# City of Phoenix Office of the City Engineer Design and Construction Procurement

### AH20620004 THE MORELAND REBID

### **ADDENDUM NO. 1**

ISSUE DATE: September 14, 2023

4804-A

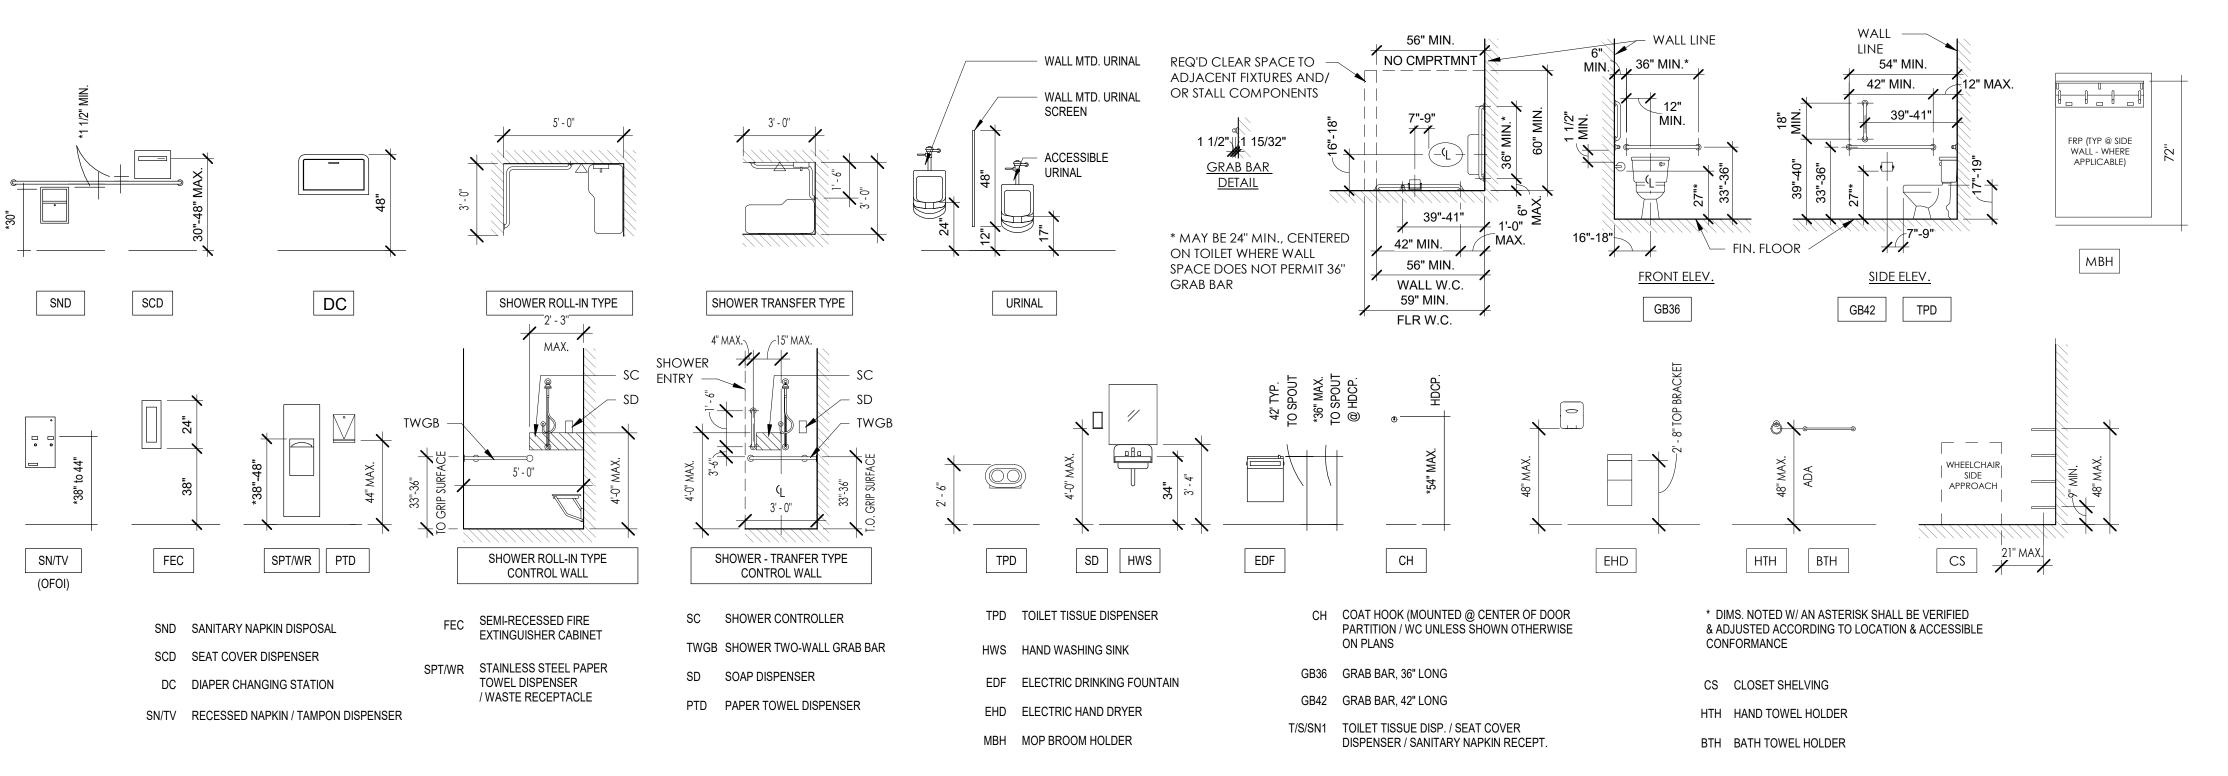
Q1.	Sheet A803-A is showing a Master Finish legend that has LVT Hatching & location callouts that aren't matching up with the Finished Floor plan. LVT-1 Location callout is residential units but the floor hatching is shown through the corridors, but the Corridors is supposed to				
	show LVT-3. LVT-2 Location is calling out Unit Restrooms, but the Hatching seems to be				
	shown throughout the entire unit. The concern is for the price point of each of the LVT to				
	make sure of capturing the correct materials. Clarify LVT Finish locations.				
A1.	LVT finishes clarified on attached sheets and updated Master Finish Legend. Refer to Master				
	Finish Legend for residential unit bathroom floor finish. Apply transition strip at center of door panel.				
Q2.	The first floor has a hatching of Conc throughout corridors, but also shows Unit LVT				
	continuing into the corridor. Will the unit LVT continue into the corridor, or will it be terminated at the unit doorway?

A2.	The LVT on the ground floor will terminate at the unit doorway. See updated sheets.				
Q3.	The plans only show finishes for Building 1 & Building 2 for a total of 132 units, but the Plans				
	scope of work on Sheet G101-A description includes a Building 3 for a total of 237 units.				
	Confirm if Building 3 is part of this scope of work or part of this phase and If it is part of this scope of work, are there plans for Building 3?				
A3.	Building 3 is not part of this scope, only Buildings 1 and 2 for a total of 132 units. Scope of				
Αυ.	Work description has been updated on sheet G101-A.				
	Tronk decomplian flag pool apaded on effect of the				
Q4.	Referring to Building 2, finish callouts for Trash Rooms, Bicycle areas, Stair/Elevator Corrido or Stairs appears to be missing. Are any of the areas in Building 2 receiving finishes?				
A4.	a. Trash Rooms: Sealed Concrete
